NL-21-0845
10 CFR 50.90ATTN: Document Control Desk
U. S. Nuclear Regulatory Commission
Washington, D. C. 20555-0001Vogtle Electric Generating Plant Units 1&2
Docket Nos. 50-424, 50-425Subject: License Amendment Request: Revise Technical Specification 3.7.2 Limiting
Condition for Operation to Remove One Main Steam Isolation Valve System

License Amendment Request: Revise Technical Specification 3.7.2 Limiting Condition for Operation to Remove One Main Steam Isolation Valve System

Evaluation of the Proposed Change

Proposed TS 3.7.2

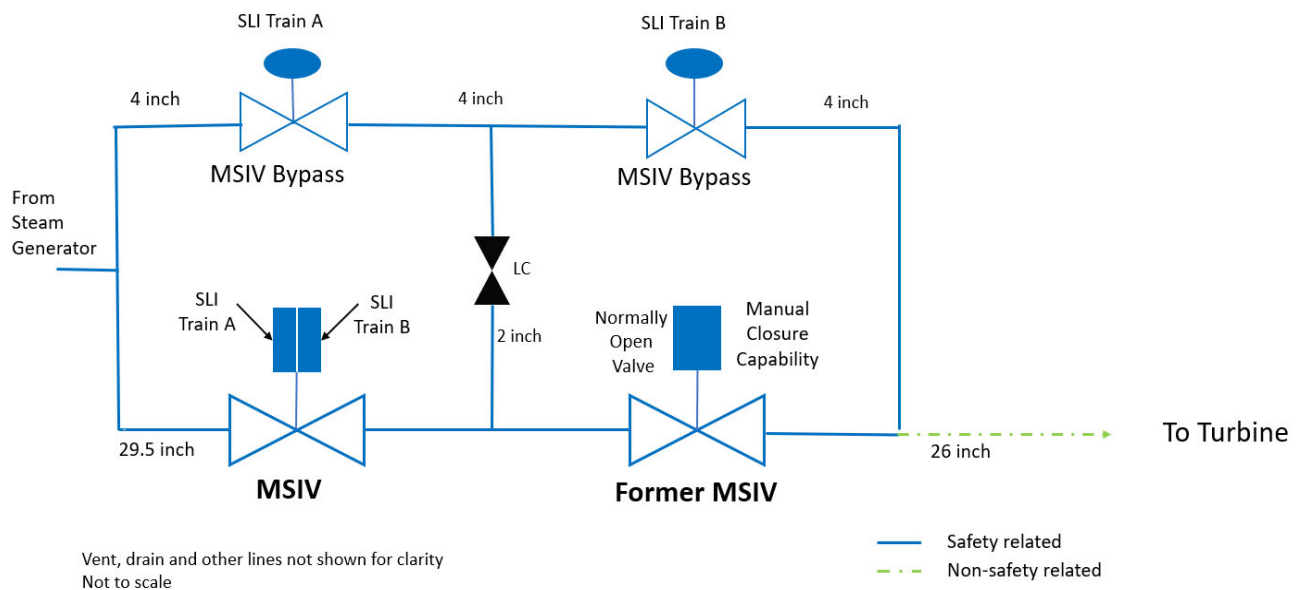
SNC proposes to change TS 3.7.2 as described below. These changes bring TS 3.7.2 closer to conformance with NUREG-1431, rev. 4, Improved Standard Technical Specifications for Westinghouse Plants (Reference 2). Additionally, changes are made to add dual train actuators and the bypass valves to the LCO, Conditions and SRs. Changes to each part of the TS are described below and discussed in detail in Section 3.

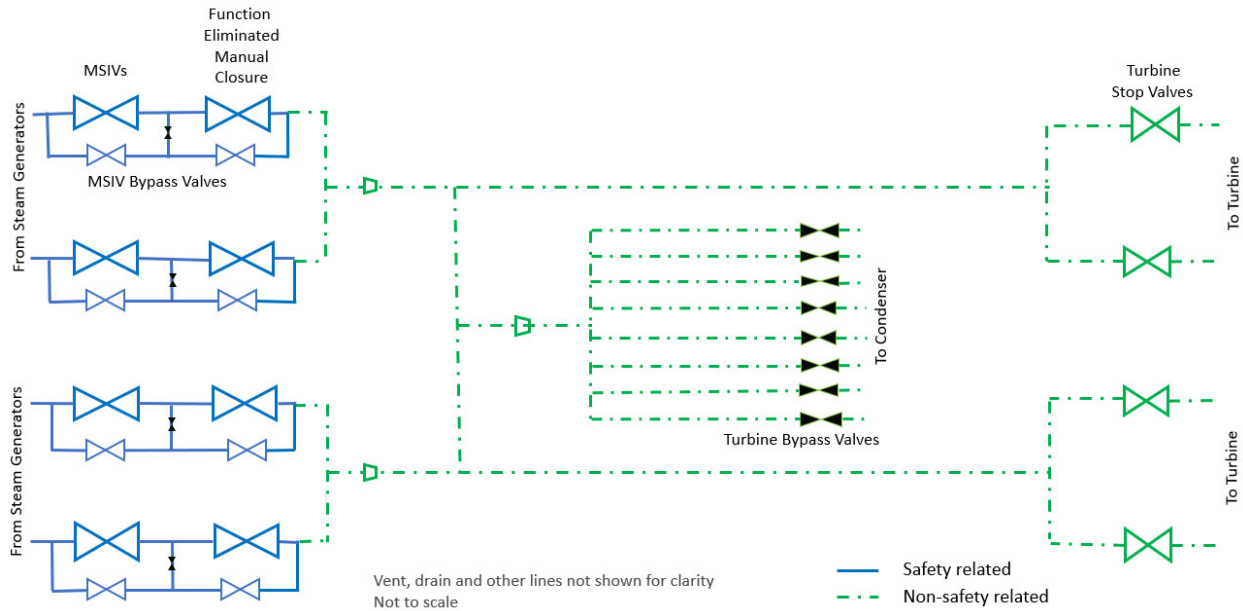
SNC proposes to change the licensing basis to eliminate the requirement for the automatic closure function from the outboard MSIV in each main steam line. The change to the plant design will be implemented upon approval of this licensing change. Both MSIVs will remain in the main steam line, in their current location. The inboard MSIV will have a new dual train actuator installed with redundant actuation signals and redundant power supplies. The existing actuator will remain on the outboard valve (former MSIV) and will be capable of manual valve closure. Automatic closure of the outboard valve will be precluded by removal of the automatic actuation signal and depressurization of the nitrogen accumulator. The outboard valve will still be capable of manual closure using the existing actuator upon charging of the nitrogen accumulator. The MSIV bypass valves remain in place with their existing closure signals. The non-safety related valves downstream of the outboard valve are not altered by this change.

Figure 8. Keep Open Schematic

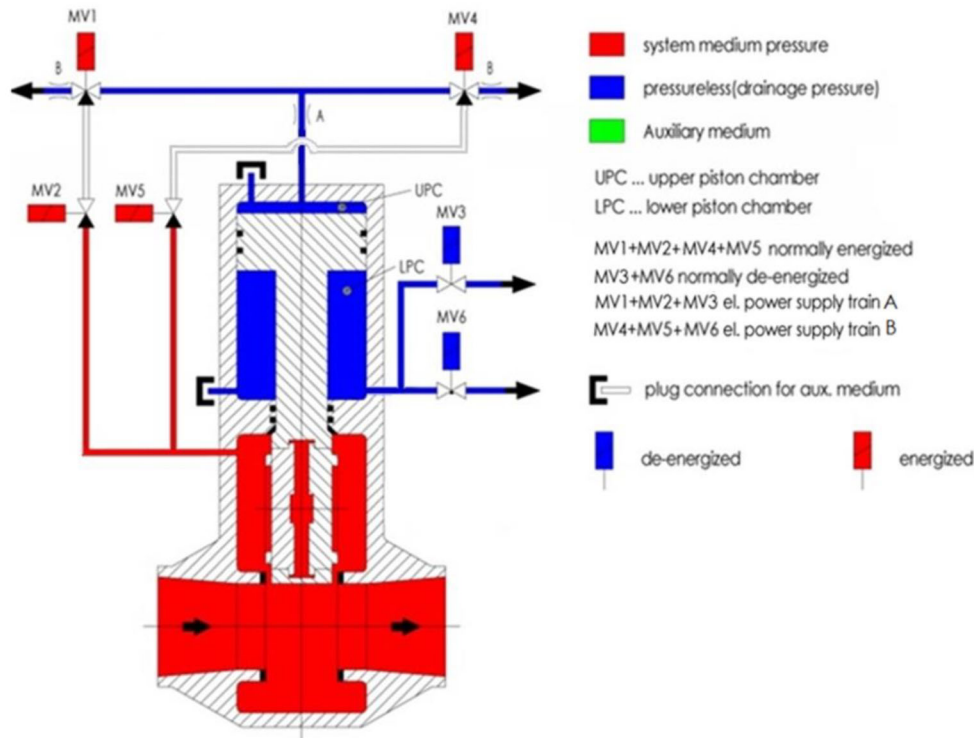
The output from these isolation signals is supplied to the solenoid valves that operate the actuator. SLI-A actuates the A train of solenoids and SLI-B actuates the B train solenoids. Each set of solenoids causes the actuator to operate, independent of the other set of solenoids. Either train A or B of the actuator is capable of causing the actuator to close the MSIV in the time assumed by the safety analysis.
